Office Action Summary	Application No.	Applicant(s)	
	10/511,444	RIEDEL, UWE JOHANN	
	Examiner	Art Unit	
	Marissa L. Ferguson-Samreth	2854

DETAILED ACTION

FIG. 1

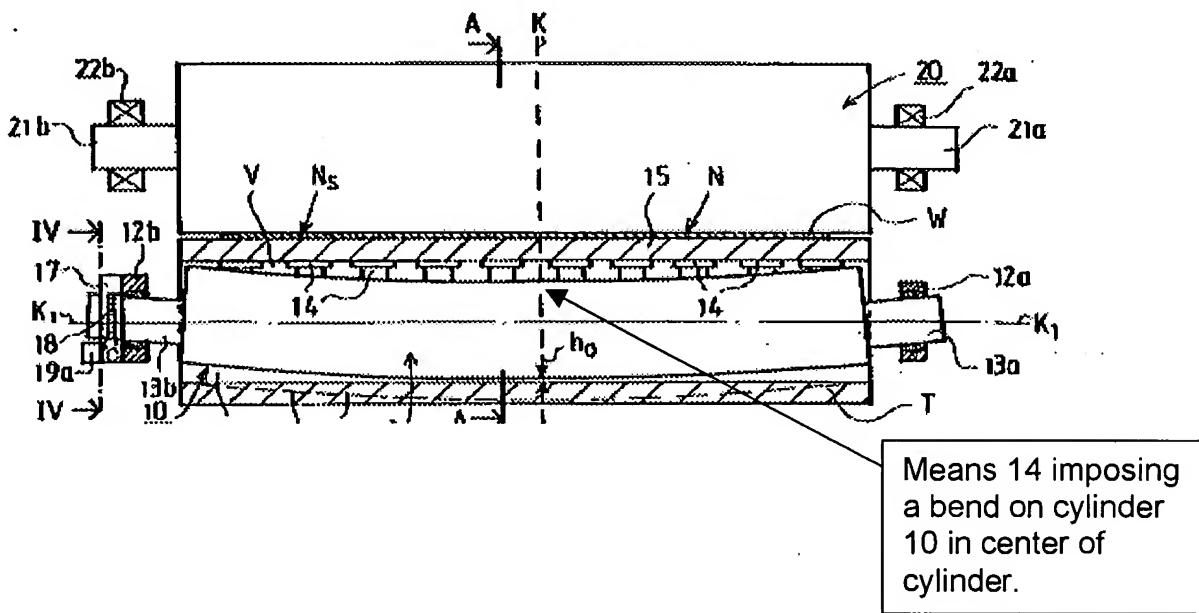
Regarding claim 31, Niskanen et al. teaches a means (13a, 13b) supporting the cylinder (10) for rotation in a web-travel direction about an axis of rotation and a means (14) imposing a bend on said cylinder in one of a direction in, and opposite to web travel direction (refer to figure 1 below).

Regarding claim 32, Niskanen et al. teaches wherein a cylinder bend is imposed on a center section of the cylinder in the web running direction (refer to figure 1 above).

Regarding claim 43, Niskanen et al. teaches wherein the bend (refer to figure 1 on page 4) is perpendicular to the web travel direction (W).
